Limerick Generating Station, Unit 1
Facility Operating License No. NPF-39
NRC Docket No. 50-352

Subject: Response to Request for Additional Information - License Amendment Request Concerning Safety Limit Minimum Critical Power Ratio Change

**Exelon Response to RAI Questions 2 and 7 for
LAR Concerning SLMCPR Change**

LGS Power Flow Operation Map
OPRM Inoperable - ALL Feedwater Heaters In Service

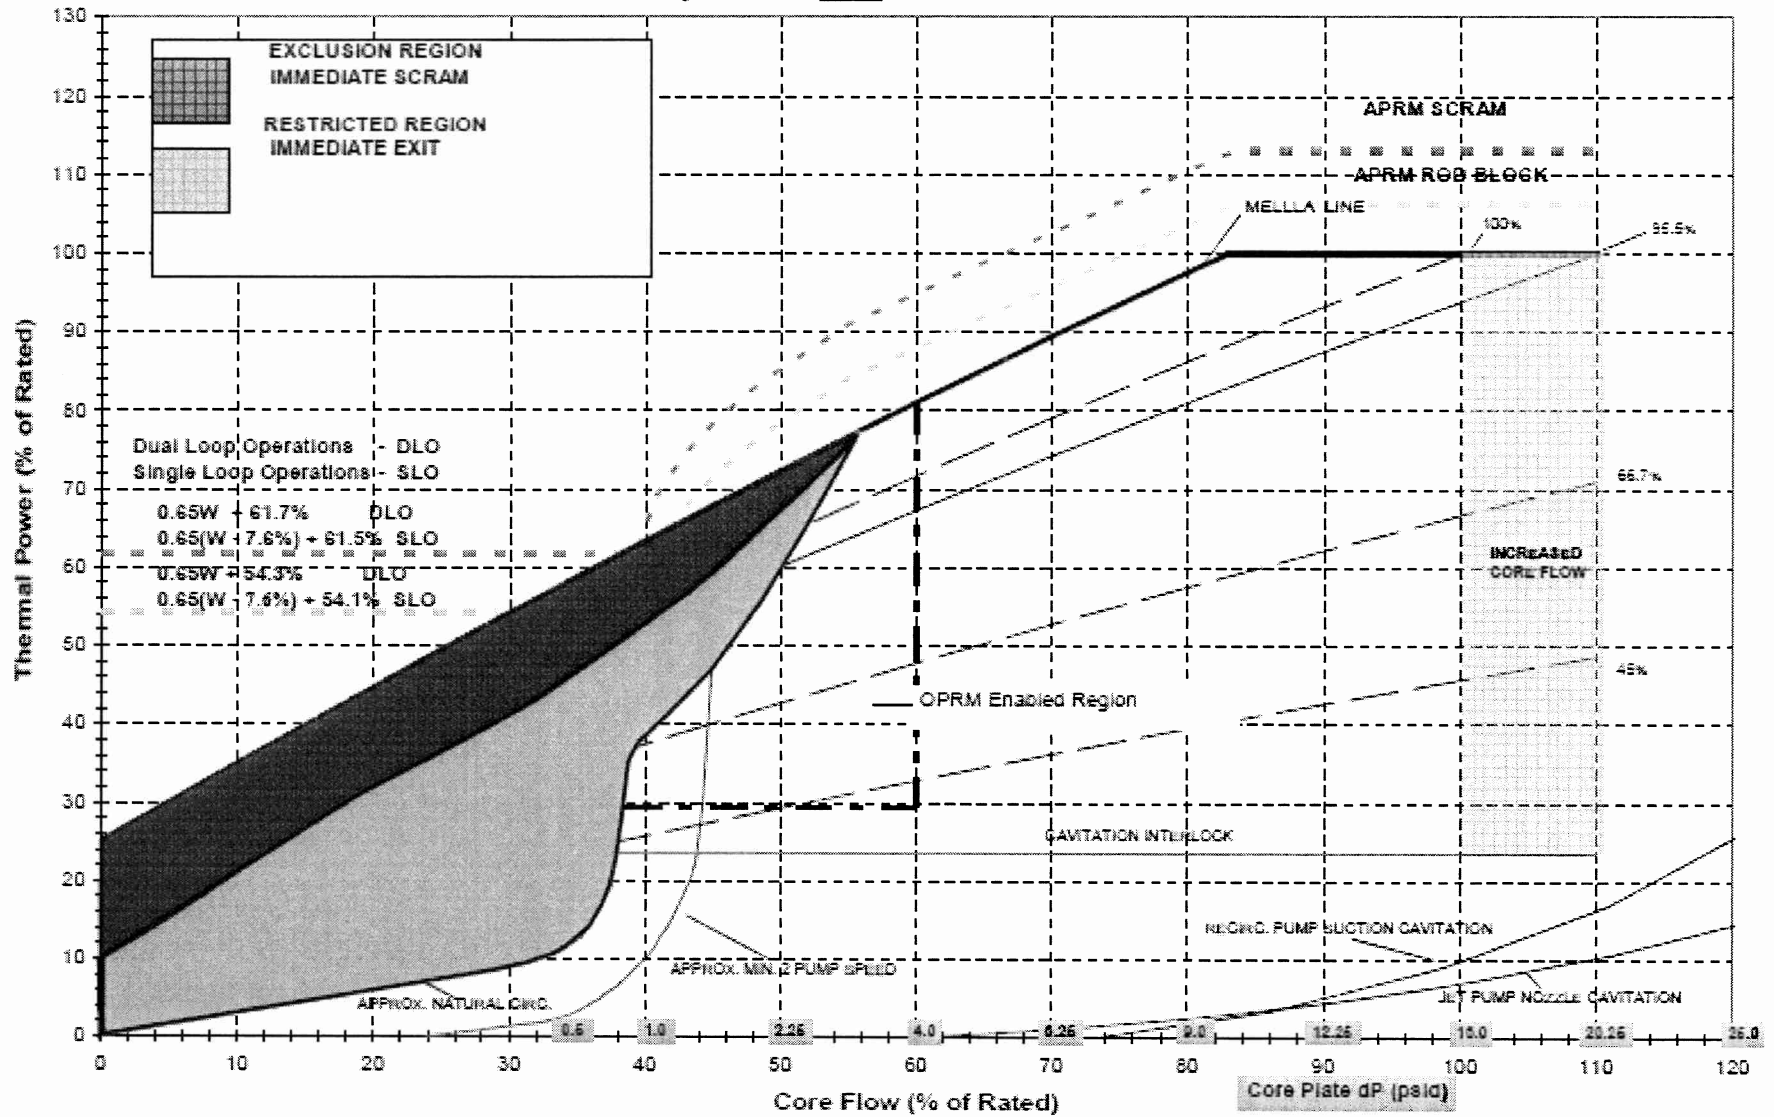
"7. Please provide an updated version of power/flow map for Cycle 15 operation, including stability Option III features of scram region and controlled entry region, based on the Boiling Water Reactor Owners Group position, as specified in NEDO-31960, for SLO and TLO."

The following is the power/flow map for back-up stability protection at LGS, Unit 1. LGS, Unit 1 does not use the controlled entry region. Instead, this region is conservatively treated as an "Immediate Exit" region on the power/flow map. The power/flow map also shows the "Immediate Scram" region. The Backup Stability Protection (BSP) region boundaries are calculated based on a specified core decay ratio per the approved stability methodology described in GESTAR (Section S.4.2.2, pg. US-38). The core decay ratio is a function of principal reactor core parameters (e.g., power and power distribution, flow, subcooling, fuel design, etc.). The core decay ratio is independent of the core flow mode – it is the same for two loop operation (TLO) and single loop operation (SLO). Therefore, the calculated BSP regions are bounding and applicable for both TLO and SLO. The power/flow map generally depicts a "natural circulation" flow line and a "maximum rod line". The BSP region boundaries are calculated based on points on the natural circulation line and the maximum rod line (identified as the MELLLA line) and the BSP regions are depicted as areas between the maximum rod line, the natural circulation line and the BSP region boundaries in the high-power, low-flow region of the map. However, the natural circulation line is approximate and the core flow measurement uncertainty is larger at low flow conditions. In the past, this has resulted in operating conditions in which the indicated power/flow condition was below (to the left of) the natural circulation line on the power/flow map. To address this situation, an operational decision was made to conservatively extend operating boundaries (e.g., maximum rod line,

stability regions, etc.) back to "zero flow". This operational enhancement to the power/flow map has been made to provide additional guidance for the unlikely, but possible circumstance of operating at these conditions.
